NOTE FOR PUBLIC WORKS SUBCOMMITTEE OF FINANCE COMMITTEE

Supplementary information on 643TH – Trunk Road T7 in Ma On Shan

馬鞍山 T7 號主幹路 TRUNK ROAD T7 IN MA ON SHAN

繪圖 drawn W. K. CHUI	簽署 initial [Signature]	日期 date 10.1.2000	比例 scale 1 : 10 000
核對 checked W. H. KWAN	簽署 initial [Signature]	日期 date 10.1.2000	圖則編號 drawing no. ST1991 A
核准 approved W. TSUI	簽署 initial [Signature]	日期 date 10.1.2000

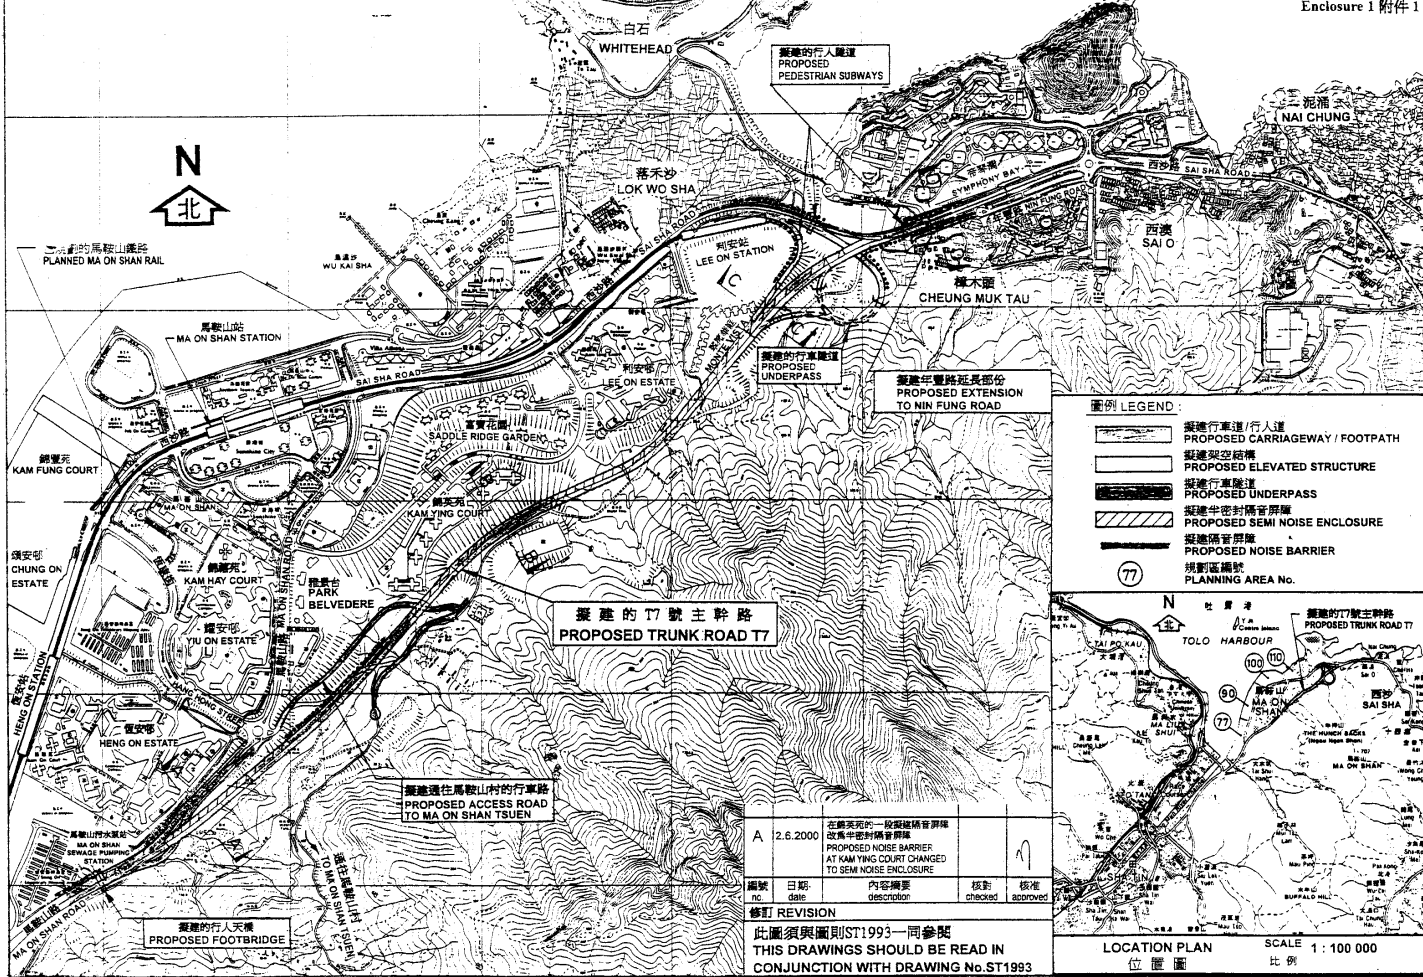
In considering PWSC(2000-01)34 on 24 May 2000 on **643TH - Trunk Road T7 in Ma On Shan**, Members asked the Administration to clarify the basis for recommending the construction of cantilever, as against semi-enclosed, noise barriers along various sections of the proposed road. Members also queried the adequacy of the cantilever noise barriers proposed at three sections near Heng On Estate, Kam Ying Court and Symphony Bay.

3. While Members noted that the traffic noise at the two sections near Heng On Estate and Symphony Bay would be adequately mitigated by cantilever noise barriers, they maintained that semi-enclosed noise barriers should be installed at the section near Kam Ying Court because the existing background noise level at that site was very low. Members also asked if the Administration could consider replacing some of the semi-enclosed noise barriers at the northern part of the Road by cantilever ones (provided noise standards could be met) to minimise the overall expenditure on noise barriers.

- (a) changing the proposed cantilever noise barriers opposite to Kam Ying Court to semi-enclosed noise barriers and
- (b) swapping the arrangements - i.e. changing the proposed cantilever noise barriers opposite to Kam Ying Court to semi-enclosed noise barriers, but replacing the semi-enclosed noise barriers at the sections towards Cheung Muk Tau in the north-east direction with cantilever noise barriers.

6. For option (a) above, noise calculations indicate that the traffic noise levels at the NSRs at Kam Ying Court will be reduced by a maximum of 13dB depending on the location of the various receivers. A comparison of the predicted noise levels after mitigation by different types of noise barriers and their respective costs are shown in the table below -

8. We are satisfied that cantilever noise barriers at Kam Ying Court would suffice to keep noise levels from T7 within 70dB. Also, cantilever noise barriers are generally less visually intrusive compared with semi-enclosed ones. Thus, as a general practice, we prefer this option whenever other requirements are satisfied. However, we accept that the background noise at Kam Ying Court is very low at present and in this case we believe there is scope for considering a higher level of mitigation to minimise the difference between the “before and after” situations. We believe it is not unreasonable therefore to change the proposed cantilever noise barriers near Kam Ying Court to semi-enclosed noise barriers, especially since the additional cost can be absorbed by the contingencies in the project estimates. A revised plan showing the latest layout of noise barriers is at Enclosure 1. We plan to upgrade this project to Category A in June 2000 for construction to commence in November 2000. The timely completion of the Trunk Road T7 is essential to improve the traffic condition in Ma On Shan.

A	2.6.2000	在圖表內的一段擬議隔音屏障改為半密封隔音屏障 PROPOSED NOISE BARRIER AT KAM YING COURT CHANGED TO SEMI NOISE ENCLOSURE		
編號 no.	日期 date	內容摘要 descriptor	核對 checked	核准 approved
